## ADDENDUM 1

### ADDENDUM DATE: December 26, 2024

- PROJECT: McGee Building "One Door" Renovation Phase 1 3505 Arendell St Morehead City, NC 28557
- OWNER: Carteret Community College 3505 Arendell St Morehead City, NC 28557
- ARCHITECT: Smith Sinnett Architecture, P.A. 4600 Lake Boone Trail, Suite 205 Raleigh, North Carolina 27607
- BIDS DUE: 2:00pm January 07, 2025 McGee Board Room 3505 Arendell St Morehead City, NC 28557

# CONTRACTOR WORK AREA EXHIBIT McGEE BUILDING "ONE DOOR" RENOVATION - PHASE 1 CARTERET COMMUNITY COLLEGE 2024009

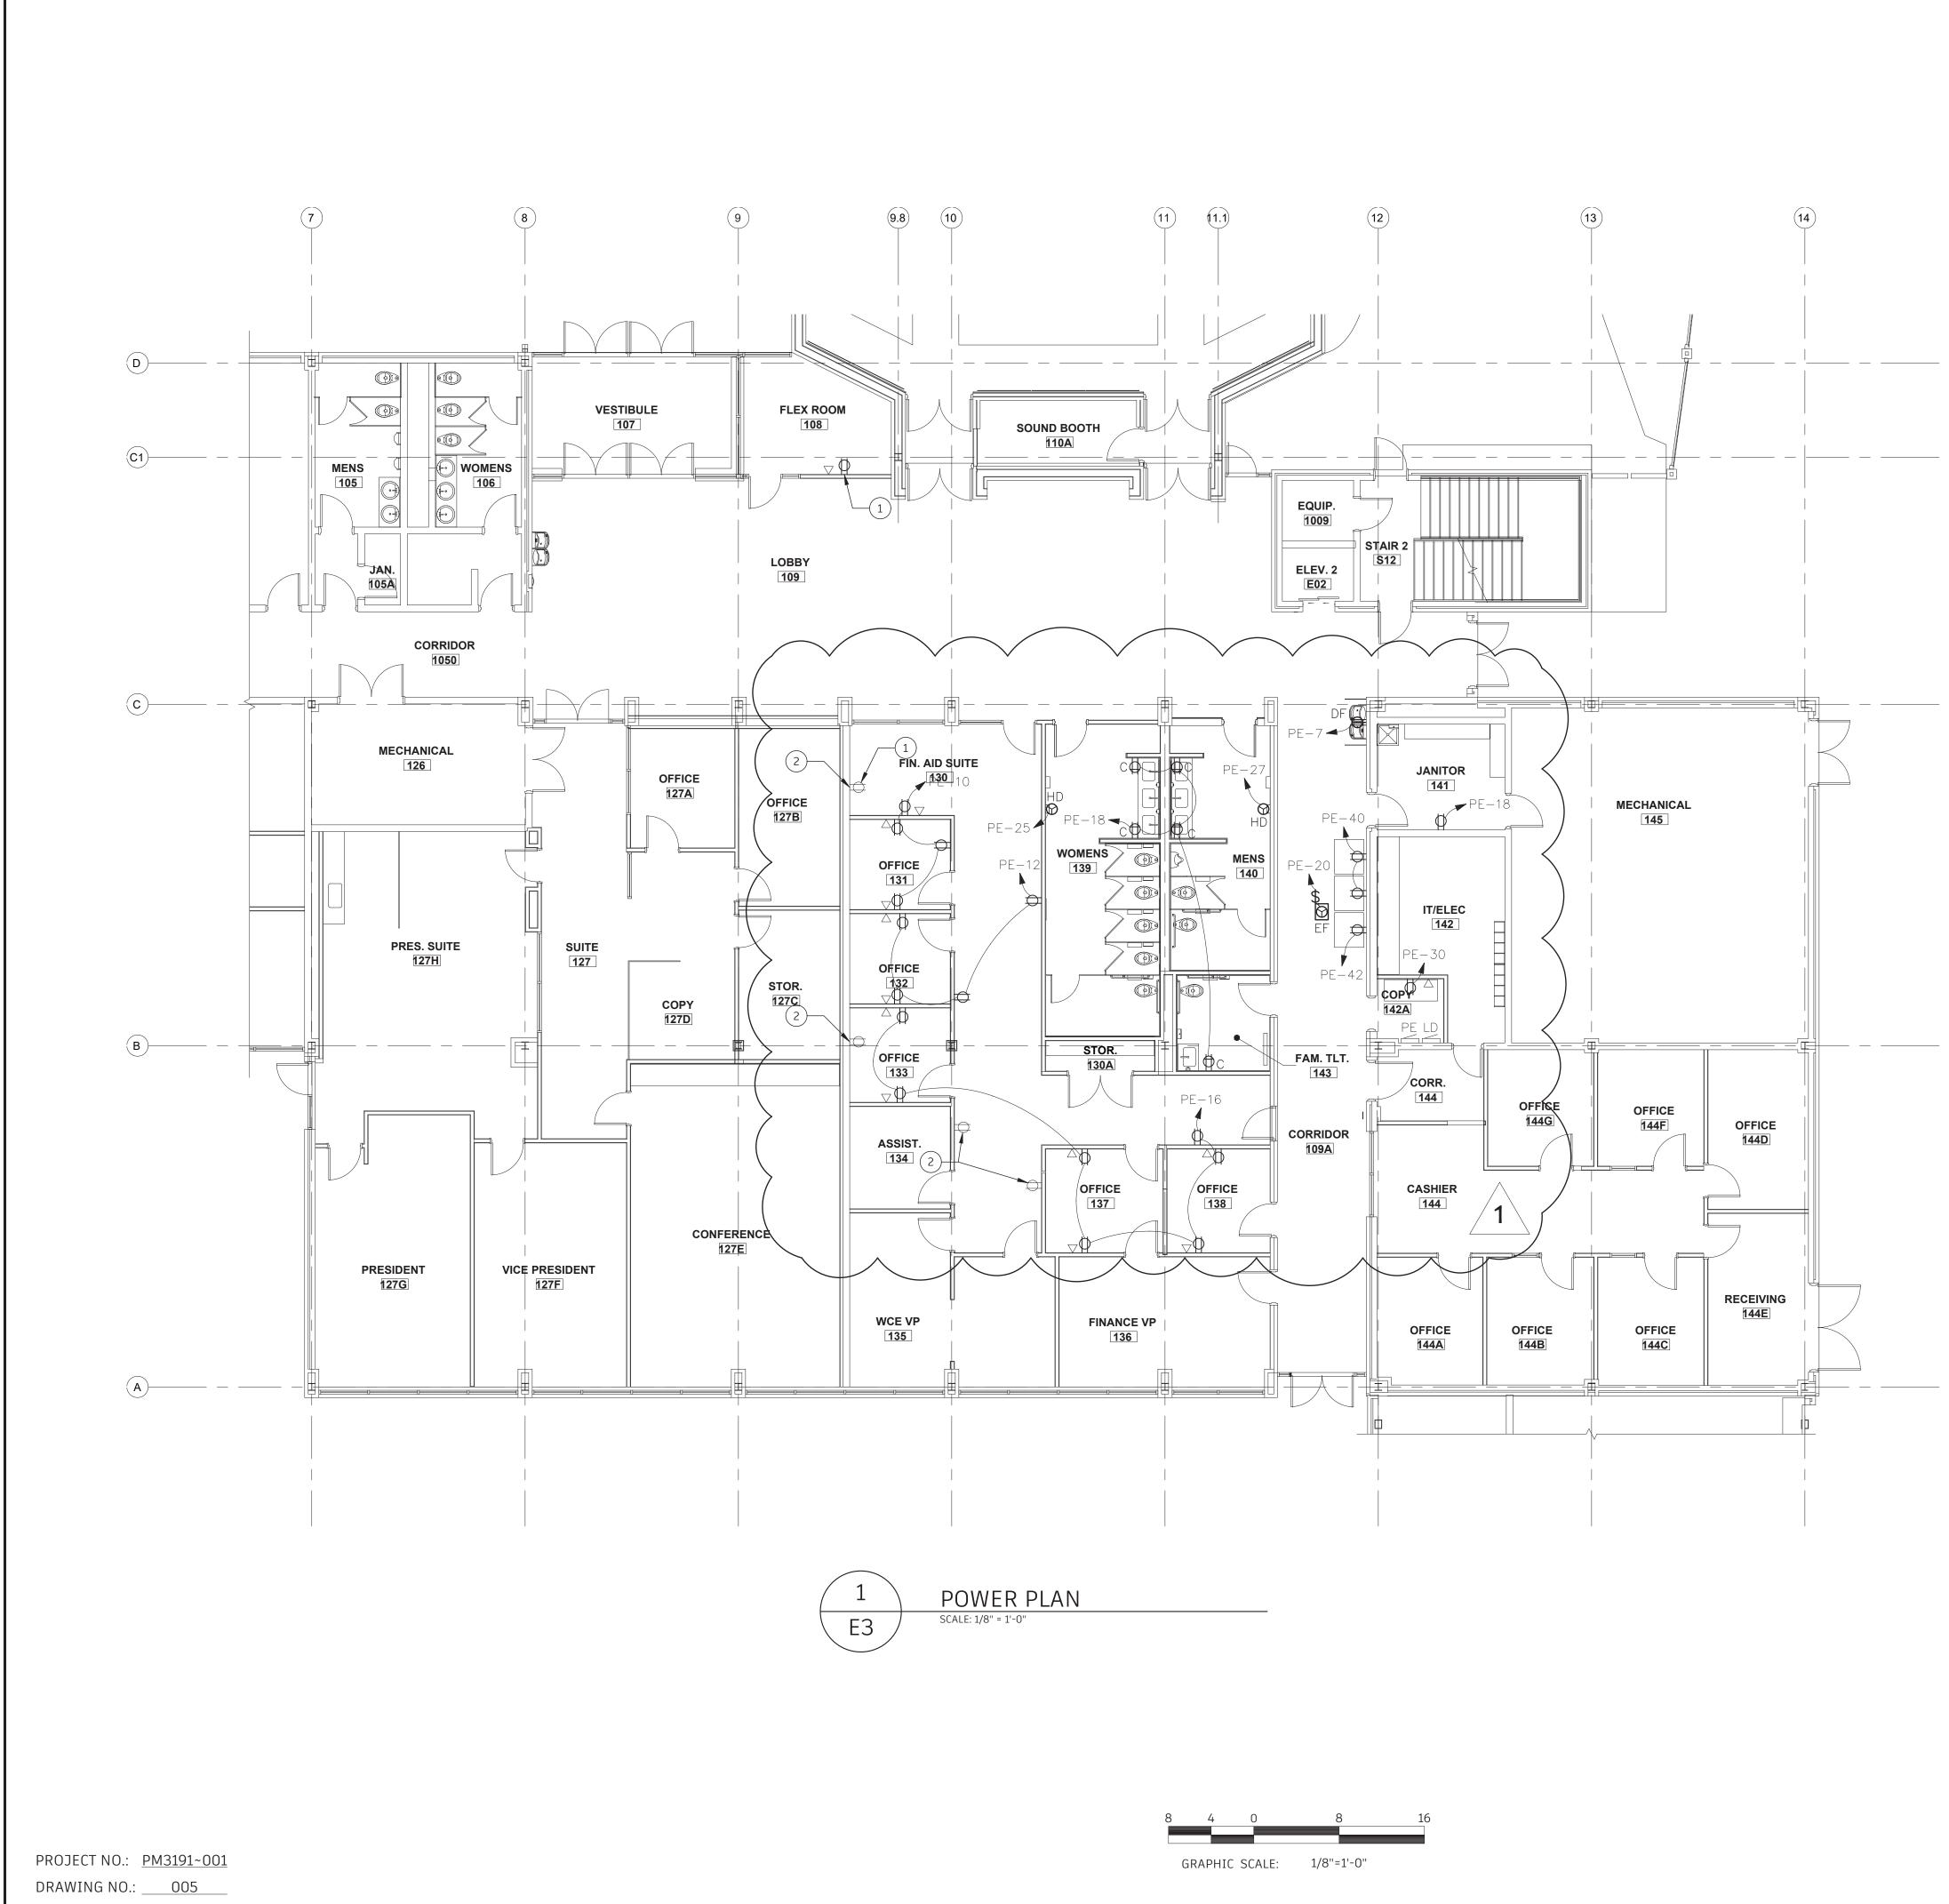
- CLARIFICATION REQUEST: Where are materials to be taken into the building and where are materials to be taken out? Is there a lay-down area?
   RESPONSE: A lay-down area will be coordinated with the owner and GC. There is a side parking lot near the welding/HVAC shops that appears ideal. See Contractor Work Area Exhibit included in this Addendum.

- 4. CLARIFICATION REQUEST: Where are dust partitions and/or floor protection needed? RESPONSE: Accessible means of egress must be maintained at all times. See contractor work area exhibit attached. Dust partitions shall be opaque and shall be provided to separate all construction areas from occupied areas so students/staff/visitors cannot accidentally walk into or entry the construction work area. The opaque partition is required so students/staff/visitors cannot see into the construction area and gives a more presentable appearance in occupied areas.

# PLUMBING EXISTING CONDITIONS & DEMOLITION PLAN

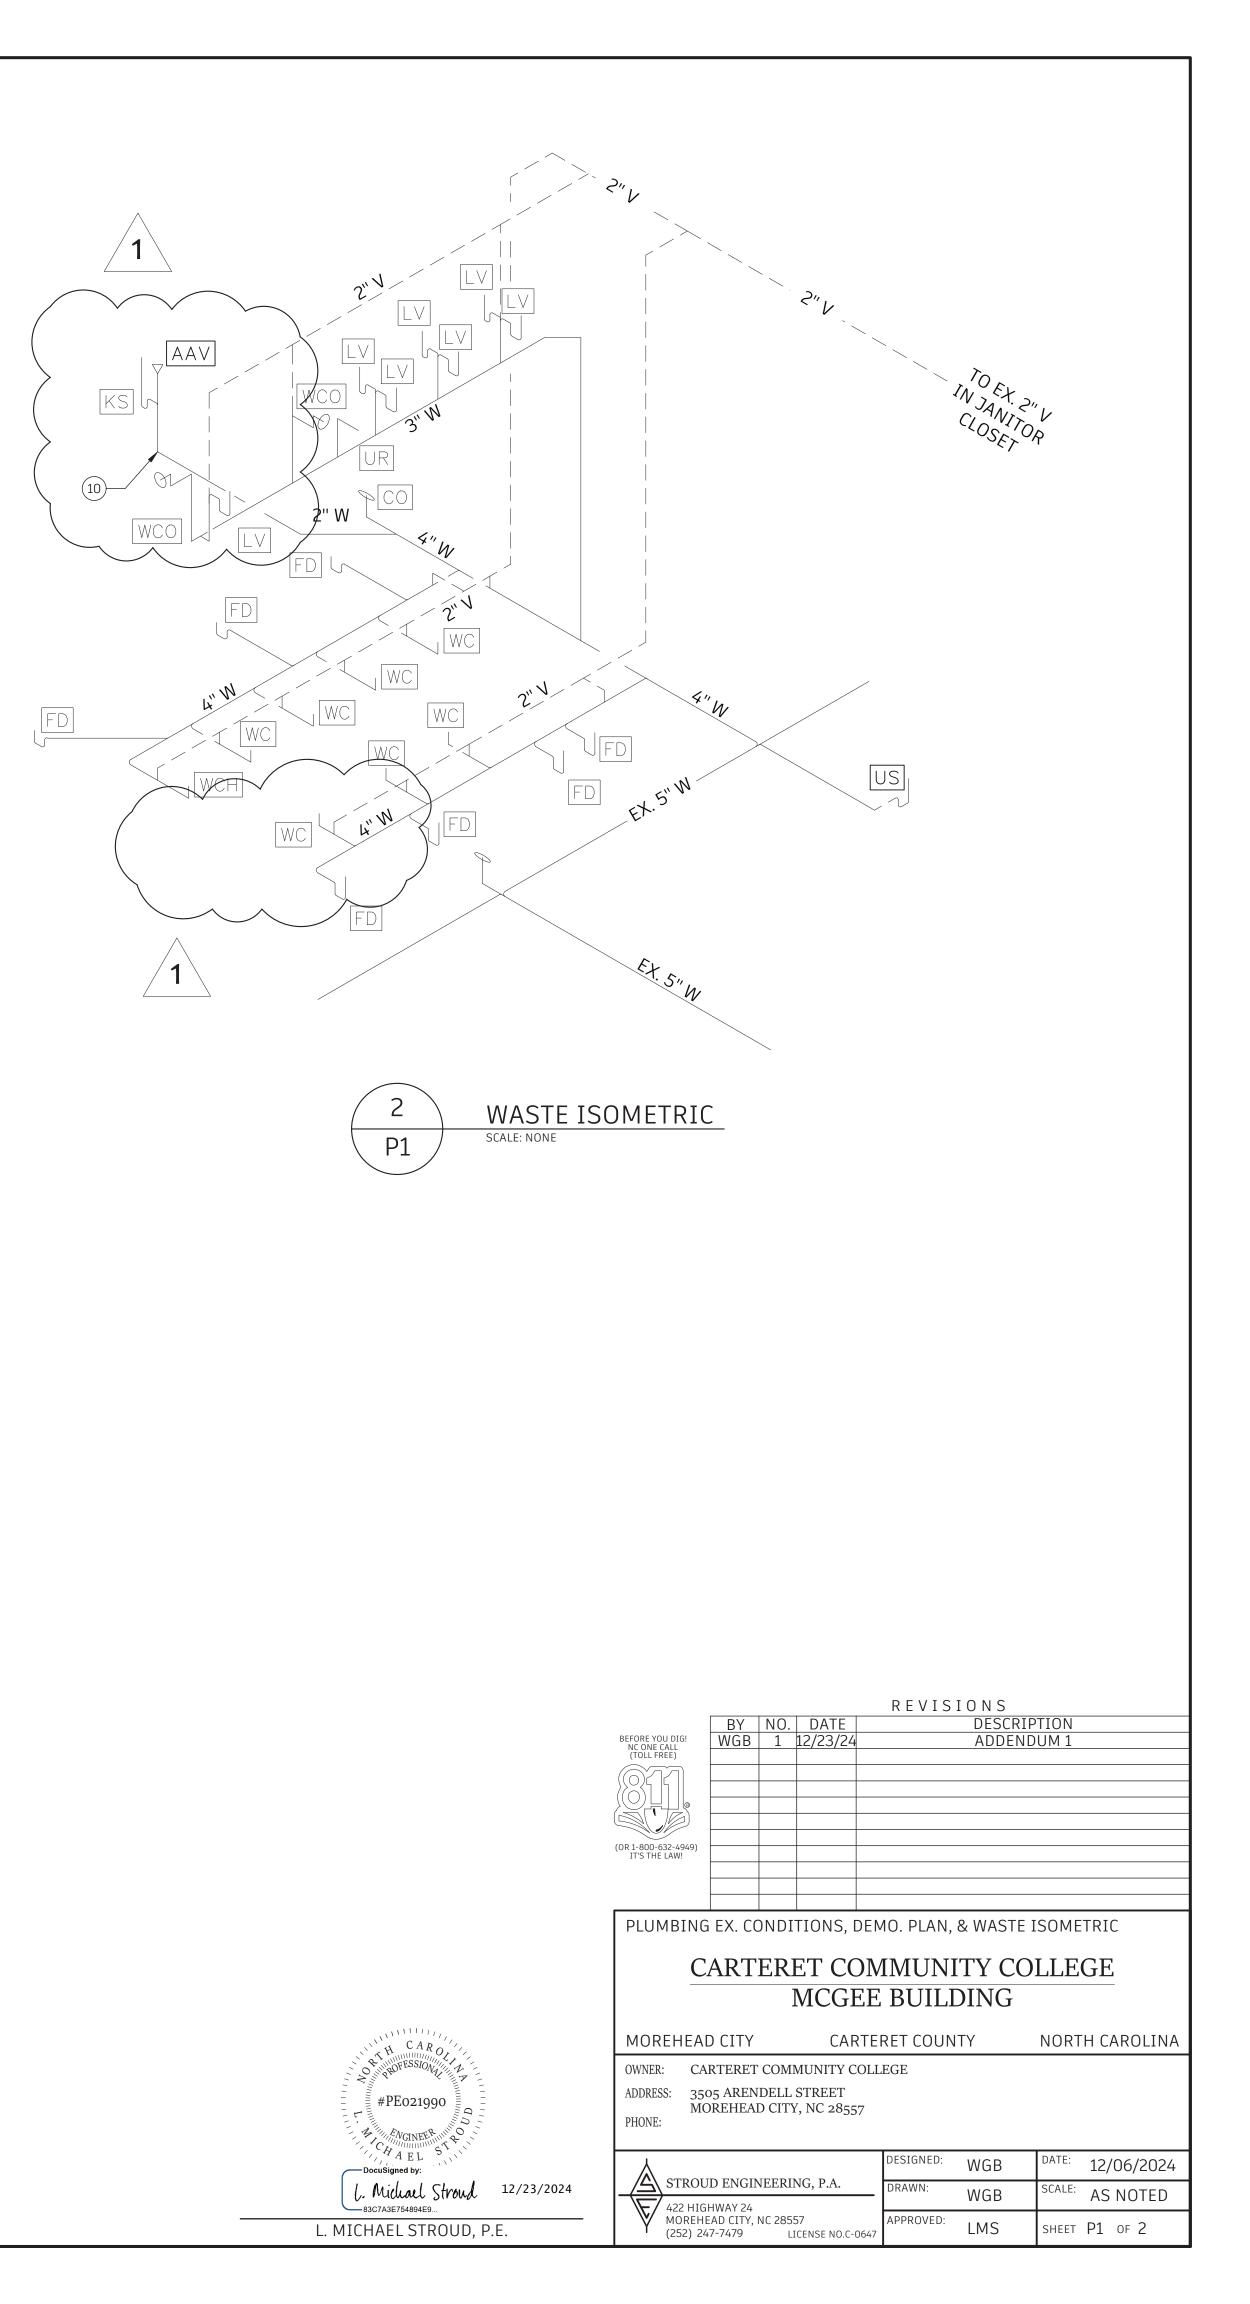
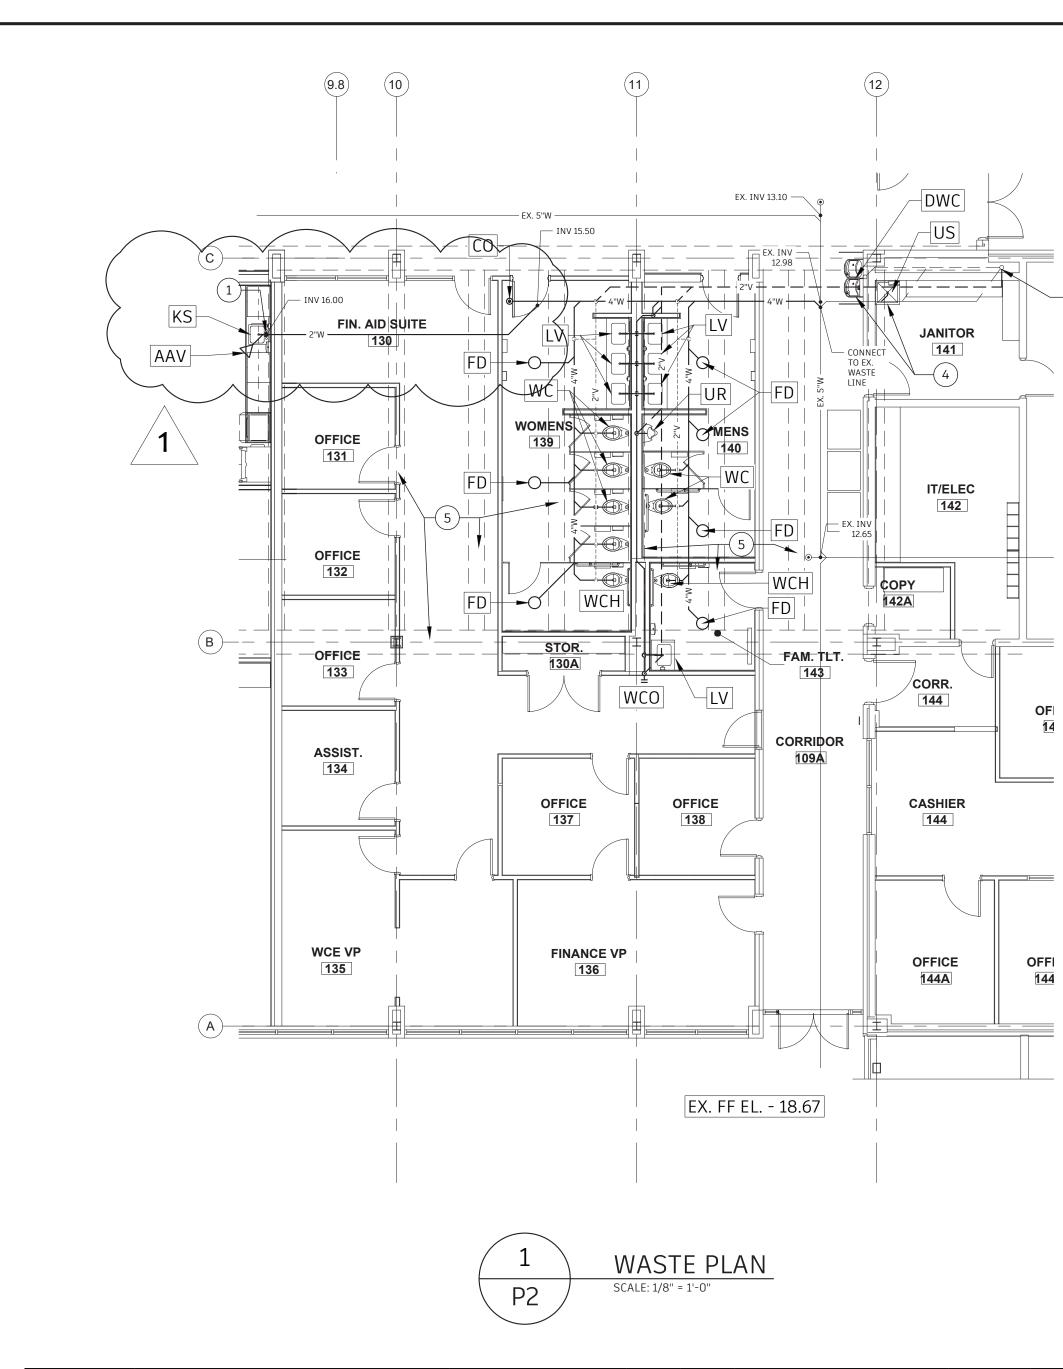
- 1. EXISTING 5" WASTE LINE.
- 2. EXISTING CLEANOUT TO REMAIN.
- 3. EXISTING 5"W CONTINUES TO EXISTING SEWER LIFT STATION.
- 4. REMOVE EXISTING TOILETS & LAVATORIES IN EXISTING BATHROOMS. CAP EXISTING WASTE & WATER LINES.
- 5. REMOVE & REPLACE EXISTING DRINKING FOUNTAIN.
- 6. EXISTING 3" DOMESTIC COLD WATER LINE.
- 7. EXISTING  $2\frac{1}{2}$ " DOMESTIC COLD WATER LINE.
- 8. EXISTING 2" DOMESTIC COLD WATER LINE.
- 9. EXISTING 1" HOT WATER LINE.
- 10. WASTE LINE TO SINK IN NEW BREAKROOM FOR ALTERNATE 1. STUB-UP WASTE LINE TO SINK AS PART OF BASE BID.
